ADDENDUM NO: 01

PROJECT: Pendleton Elementary Roofing Replacement

PROJECT NO: 2026060

DATE: 07/24/26

CERTIFIED BY:

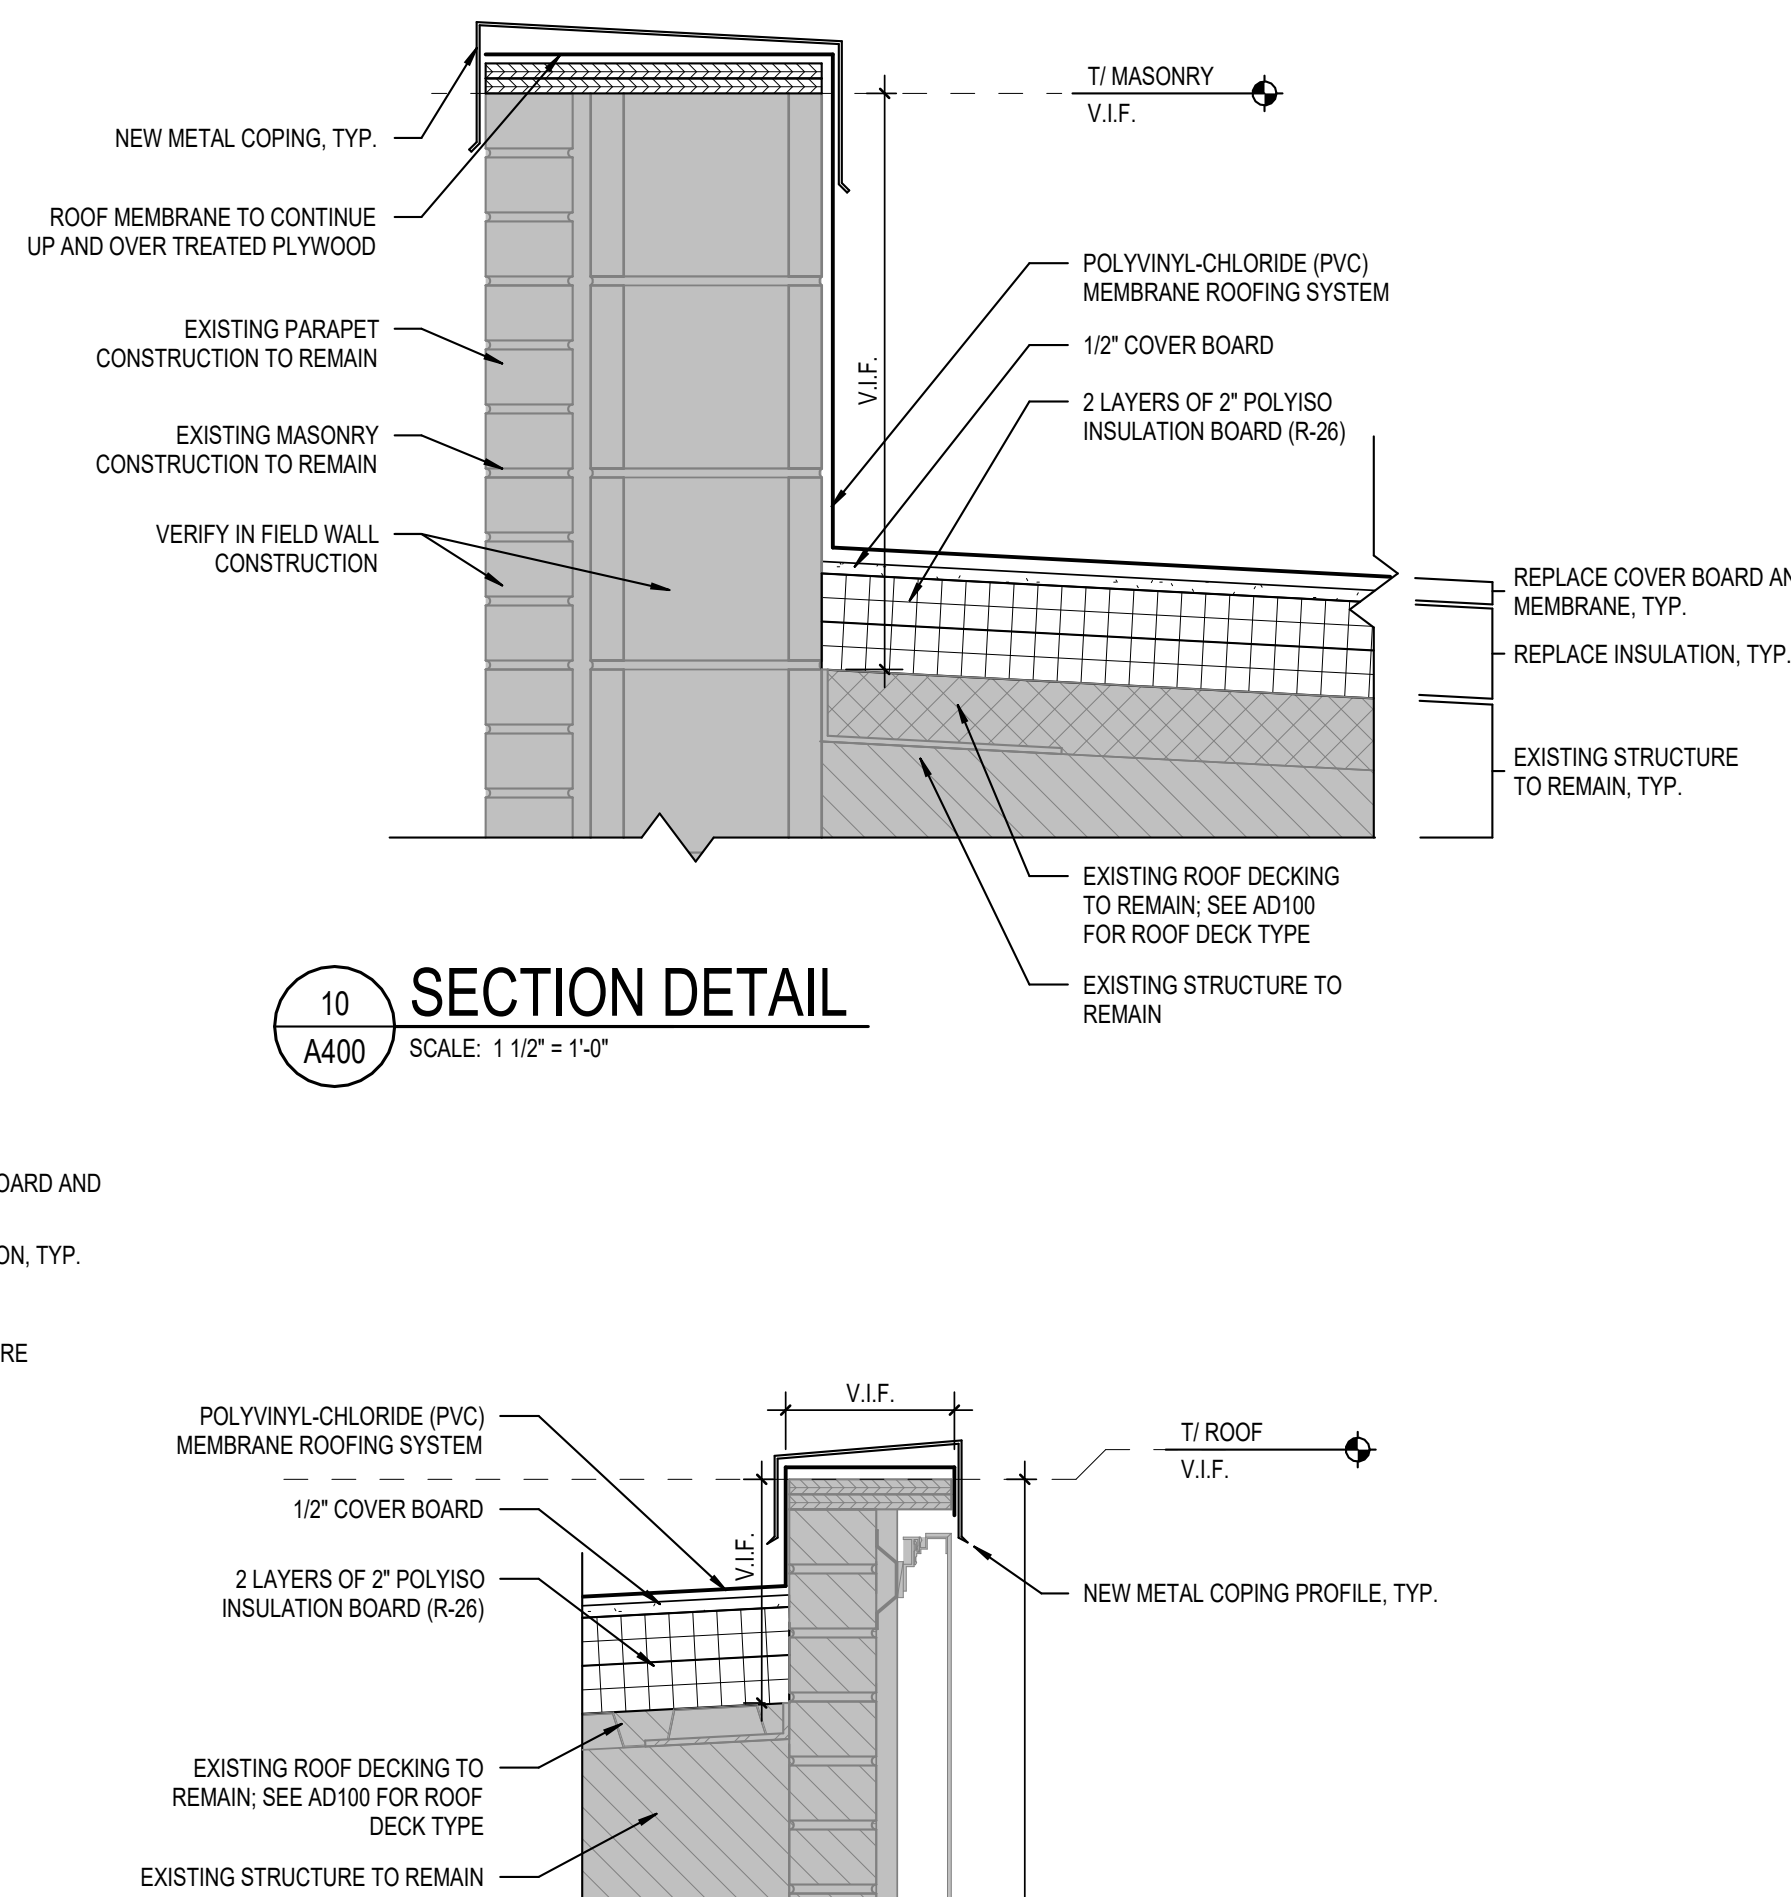
3.3 A400 – SECTION DETAILS

A. Revise all details to depict existing roof conditions.
